<p>TO: Mercedes-Benz Dealer Principals, General Managers, Sales Managers, Service Managers, Parts Managers</p>	<p>FROM: Anthony Washington, Senior Manager, Regulations and Certifications</p>
<p><b>Re: Launch Recall Campaign Notification</b> <b>Model: Sprinter</b> <b>Model Years: 2023-2024</b> <b>Replace Spring U-Bolts</b></p>	<p>DATE: August, 2024</p>

<b>Campaign No. :</b>	<b>Campaign Desc. :</b>	<b>Replace Spring U-Bolts</b>
<b>2024070014</b>	<b>VS3FEDERB</b>	
<p>This is to notify you of a <b>Recall Campaign</b> to Replace the Spring U-Bolts on approximately <b>1,214</b> MY 2023-2024 Sprinter Vans. The recall campaign will be visible on the <a href="http://www.safercar.gov">www.safercar.gov</a> website and may generate questions from customers. All affected VINs will be flagged as "<b>OPEN</b>" in VMI and cannot be sold until remedied.</p>		
<b>Background</b>		
<b>Issue</b>	<p>Mercedes-Benz AG ("MBAG"), the manufacturer of Mercedes-Benz Sprinter vehicles, has determined that on certain Sprinter (907 platform) vehicles, the material properties of the spring U-bolts might not meet current specifications. The rear axle spring U-bolts may not have undergone hardness treatment, which

D32.20-A026-79

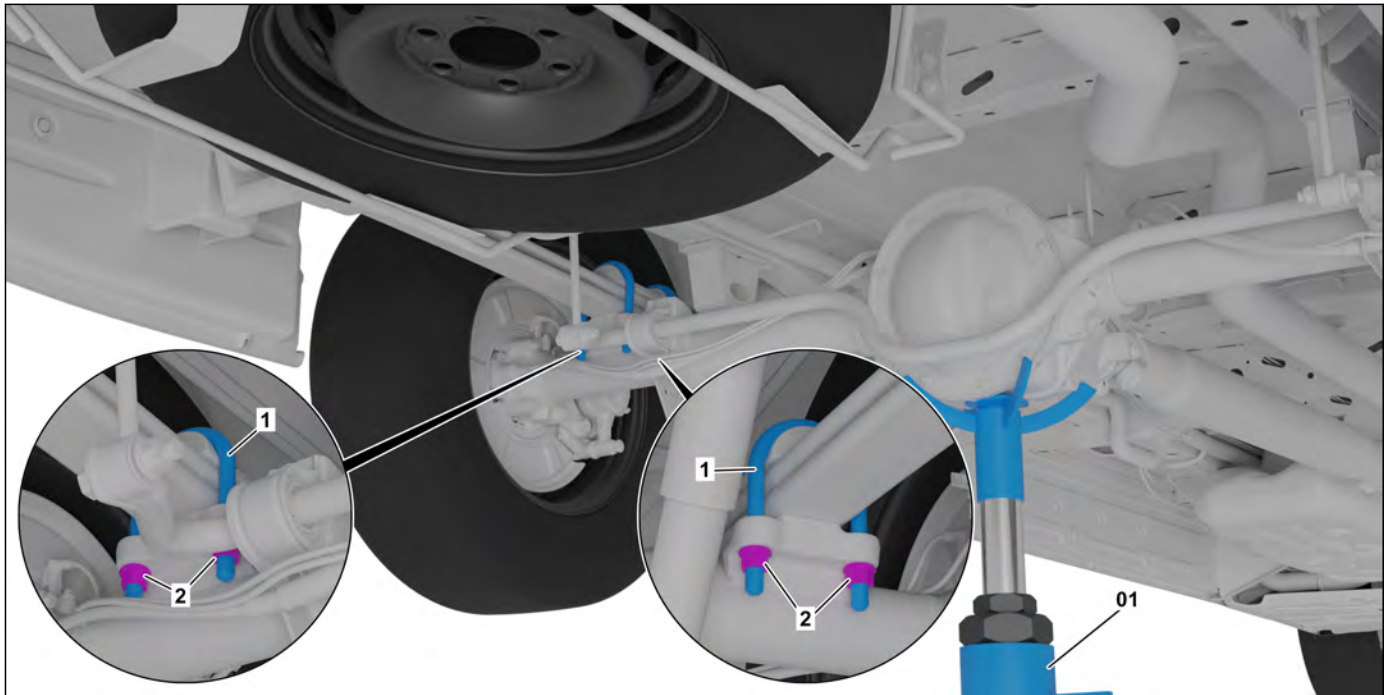
3	Support rear axle using telescopic jack (01).	⚠ Never exceed permissible working angle of installed propeller shaft when rear axle is released. Damage may occur otherwise.	
4	Replace rear spring U-bolt (1) on left side of vehicle.	<b>i</b> For this purpose, remove nuts (2). Dispose of spring U-bolt (1) and nuts (2) properly. <b>Nm</b> Nut, spring U-bolt for rear axle spring to rear axle	BA32.20-Z-1005-03KOA
5	Replace front spring U-bolt (1) on left side of vehicle.	<b>i</b> For this purpose, remove nuts (2). Dispose of spring U-bolt (1) and nuts (2) properly. <b>Nm</b> Nut, spring U-bolt for rear axle spring to rear axle	BA32.20-Z-1005-03KOA
6	Replace rear spring U-bolt (1) on right side of vehicle.	<b>i</b> For this purpose, remove nuts (2). Dispose of spring U-bolt (1) and nuts (2) properly. <b>Nm</b> Nut, spring U-bolt for rear axle spring to rear axle	BA32.20-Z-1005-03KOA
7	Replace front spring U-bolts (1) on right side of vehicle.	<b>i</b> For this purpose, remove nuts (2). Dispose of spring U-bolt (1) and nuts (2) properly. <b>Nm</b> Nut, spring U-bolt for rear axle spring to rear axle	BA32.20-Z-1005-03KOA

Number	Designation	Model 907 with code CB2 (Comfort air suspension)	Model 907.1/2 except code CB2 (Comfort air suspension)
BA32.20-Z-1005-03KOA	Nut, spring U-bolt for rear axle spring to rear axle M14x1.5	Stage 1 Nm	-
		Stage 2 $\angle^\circ$	-
		Stage 3 $\angle^\circ$	-
			150
			90

Number	Designation	Model 907.6/7/8 except code CB2 (Comfort air suspension)
BA32.20-Z-1005-03KOA	Nut, spring U-bolt for rear axle spring to rear axle M14x1.5	Stage 1 Nm
		Stage 2 $\angle^\circ$
		Stage 3 $\angle^\circ$
		150
		90
